# UNITED STATES PATENT AND TRADEMARK OFFICE

10/530,426

<b>Office Action Summary</b>	<b>Application No.</b> 10/530,426	<b>Applicant(s)</b> HABUTA ET AL.	
	<b>Examiner</b> GERARD T. HIGGINS	<b>Art Unit</b> 1794

FIG. 4B

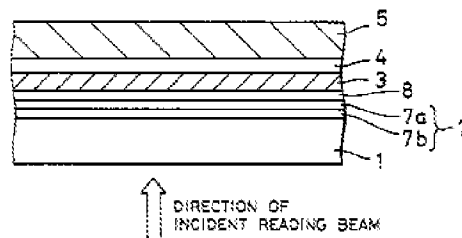
With regard to claims 1-3, Higuchi et al. disclose the dual layer optical information medium of Figure 4B (col. 7, lines 14-36).

The device is comprised of a substrate **1**, on which there are bumps and depressions in the form of pits and grooves that make up the first optical information layer (col. 5, line 51 to col. 6, line 7). The laser for recording or reproduction is incident from the first information layer side of the medium. The layer **7b** is the transmittance adjustment layer, which is the same as part **2b**, which is disclosed at col. 6, lines 20-29, included among these materials are many of the materials that applicants state are completely appropriate for their invention (ZnS, ZrO<sub>2</sub>, etc.). There is a low refractive index layer **8**, which may be comprised of SiO<sub>2</sub> (col. 7, lines 24-29). Applicants state that this material is completely appropriate for their invention. There is a spacer layer **3** upon which is formed a series of bumps and depressions in the form of pits and grooves corresponding to a second information layer (col. 6, lines 30-43). The Examiner deems that pits and grooves represent a first information layer that can change between two optically different states, as these features represent recorded data.

With regard to claims 2 and 3, Higuchi et al. disclose at col. 7, lines 24-29 that the thin layer **8** is inserted to prevent other layers from being affected by moisture; further, they state that the material of the layer **8** is chosen such that it has a refractive index nearly equal to that of the spacer layer **3**. Judging by the fact that the materials of

Higuchi et al. disclose all of the limitations of applicants' claim 1 in section 13 above. Additionally it disclose the reflective layer **7a** (see Figure 4B above); however, they fail to disclose the arrangement of the reflective layer seen in applicants' claim 5 and the thickness of the low refractive index layer of claim 7.

It would have been obvious to one having ordinary skill in the art at the time the invention was made to reverse the layer arrangement of the reflective layer **7a** and the

transmittance layer **7b** in the device of Figure 4B. It has been held that a mere rearrangement of parts that “would not have modified the operation of the device” is an obvious modification. Please see MPEP 2144.04 and *In re Japikse*, 181 F.2d 1019, 86 USPQ 70 (CCPA 1950). The interchangeability and addition of various reflection and dielectric layers are well known in the art of optical recording media to modify the properties of transmittance and absorption of light among the recording layers.
